S/D 89-63 - SOUTHGLEN ADDITION

STAFF REPORT
(Final Plat Approved 9/21/89)

CASE NUMBER: S/D 89-63 - SOUTHGLEN ADDITION, Replat of Tract B, Lot 2, Block A

FINAL PLAT

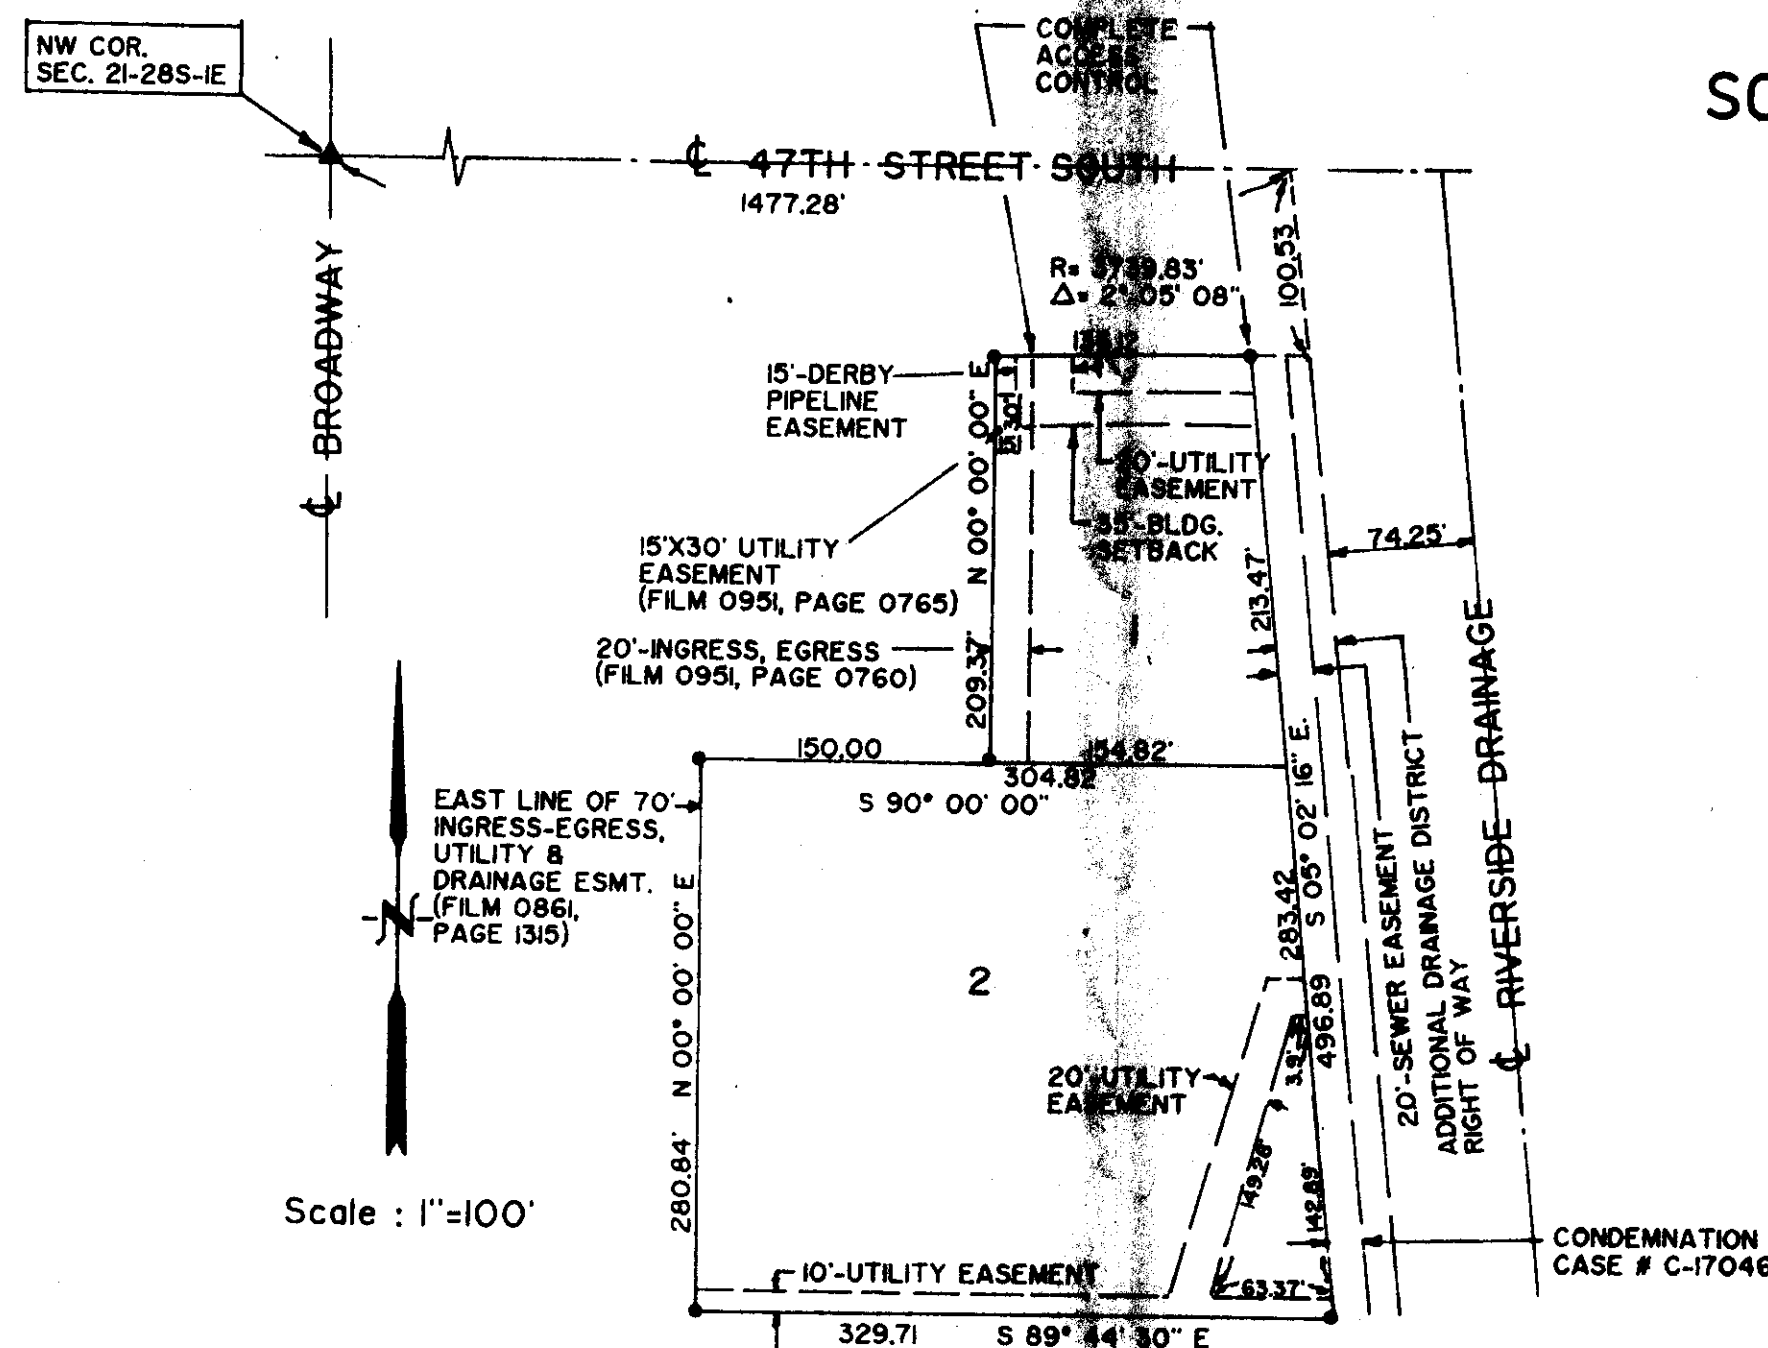
- A. Unless indicated by a revised drainage plan for this site, the applicant shall submit, for recording with the final plat tracing, a cross lot drainage agreement.

- B. The platting of the minimum building pad elevation shall be noted on the face of the plat as well as in the platlor's text. The text shall also note if the minimum elevation involves the lowest opening or floor elevation.

- C. As this property is establishing minimum building pad elevations, the face of the plat shall reference the location and elevation of permanent on-site and off-site benchmarks. Section 5-402(N).

- D. Unless a release can be provided from the pipeline company, the final plat shall indicate the recording information for the 15-foot Derby pipeline easement on this property.

- E. Any relocation, lowering or encasement of the pipeline, made necessary by this development, will not be at the expense of the City.
- F. The final plat tracing shall indicate the appropriate names in printing, of all required signatures by their corresponding signature lines. The applicant is advised that a new MAPC chairman is to be appointed September 14, 1989.

- G. Since this plat is within the City of Wichita, the access control referenced in the platlor's text should be indicated as being "guaranteed to the City of Wichita."

- H. The final plat tracing shall employ an addition name other than the one indicated on the final. Southglenn 2nd Addition would be acceptable. The legal description on the final plat shall also be amended by deleting reference to a Tract B and replacing this with an appropriate description based on the originally platted lot.

- I. In order to redistribute special assessments for this replat, the applicant shall submit, with the final plat tracing, square footage figures for the lots being platted.

- K. The applicant's engineer is advised that the Register of Deeds is requiring the name(s) of the notary public, who acknowledges the signatures on this plat, to be printed beneath the notary's signature.
